EN 13445 "Unfired pressure vessels" Maintenance Help Desk (MHD) Question form

Request reference number (to be filled by MHD): (2014)-0x-01		Date: 2017-10-26	
Please fulfil the following			
Part: EN 13445-all	Issue: 2014	Page Foreword	Subclause National Standard Reference --
Subject:			
Type of request:		<input type="checkbox"/> Technical clarification	<input checked="" type="checkbox"/> Editorial correction
		<input type="checkbox"/> Technical comment	<input type="checkbox"/> Translation correction
From : Company: UcoTek AB Name: Ulf Malmström Postal address: Iridalsvägen 1, SE-14461 Rönninge ..		e-mail: ulf@ucotek.se phone: +46707686690	
<input type="checkbox"/> Manufacturer	<input type="checkbox"/> User	<input checked="" type="checkbox"/> Other (please specify): Consultant

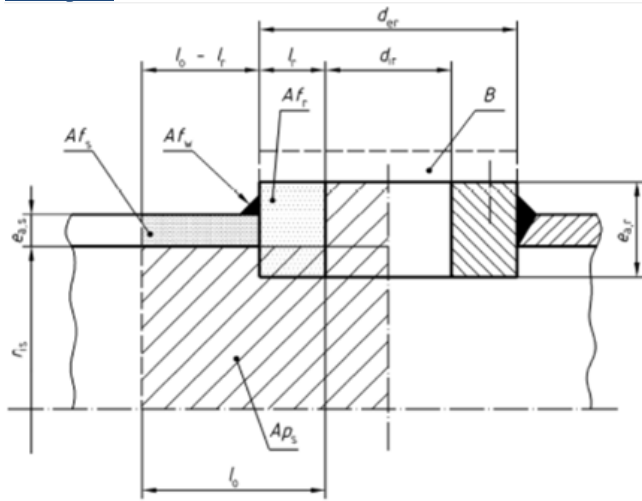
Question/comment: Formula for calculation β_{FL} (11.5-37) is wrong. The whole fraction should be multiplied by -1. See attached coefficients.xlsx file -> chart_betaFL sheet and calculation sheet. Wrong formula:					
$\beta_{FL} = \frac{C_{18} \left(\frac{3+A}{6} \right) + C_{21} \left(\frac{21+11A}{84} \right) + C_{24} \left(\frac{3+2A}{210} \right) - \left(\frac{9+5A}{360} \right)}{\left[\frac{C}{3(1-\nu^2)} \right]^{1/4} \frac{(1+A)^3}{C}}$					
Proposed answer(s): Correct formula:					
$\beta_{FL} = - \frac{C_{18} \left(\frac{3+A}{6} \right) + C_{21} \left(\frac{21+11A}{84} \right) + C_{24} \left(\frac{3+2A}{210} \right) - \left(\frac{9+5A}{360} \right)}{\left[\frac{C}{3(1-\nu^2)} \right]^{1/4} \frac{(1+A)^3}{C}}$

Answer from Olavi Valtonen:					
Proposed answer is correct, “-“ sign exists also in CODAP and ASME Code.					
To be sent to EN 13445 Maintenance Help Desk secretariat:				EN 13445 MHD secretariat c/o UNM Standardization Office on behalf of AFNOR F 92038 Paris La Défense Cedex – France e-mail: en13445@unm.fr
